REF: N212340

DATE: 17 May 2021

RE: 50-52 PHILLIP STREET, SYDNEY – TRANSPORT IMPACT ASSESSMENT PEER REVIEW

Figure 2: Sight line issue for vehicles exiting from car stacker onto Phillip Lane

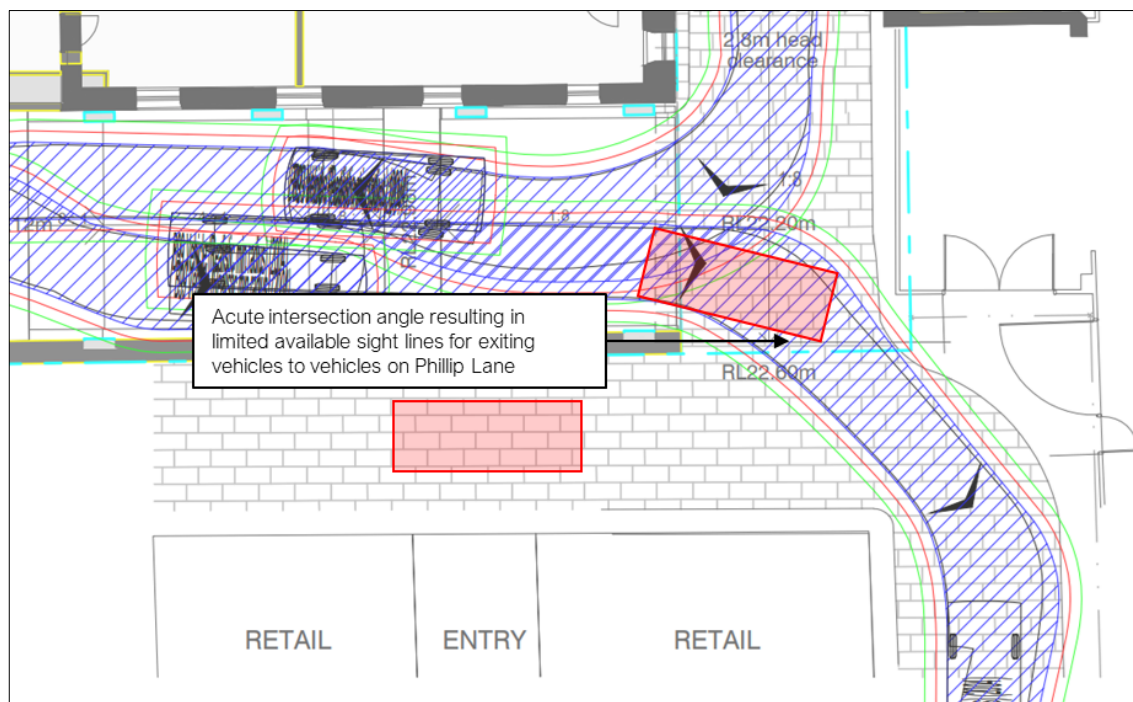
- The car stacker access ramp has no setbacks from the adjacent Phillip Lane. Cars exiting the car stacker will have very constrained (almost no) sightlines to vehicles travelling north along Phillip Lane, as shown in Figure 2. No discussion has been made as to such details and/ or management measures to deal with such safety issues. As a guide, Austroads Guide to Road Design Part 4A: Unsignalised and Signalised Intersections recommends vehicles approach an intersection at an angle no less than 70 degrees to ensure a safe and convenient observation angle is maintained. It is recommended that this detail be assessed accordingly.

- The current location of the ramp with respect to its setback from Phillip Lane results in restricted sight lines for vehicles exiting the car stacker and vehicles on Phillip Lane. No management measures, or practical solutions have been presented.
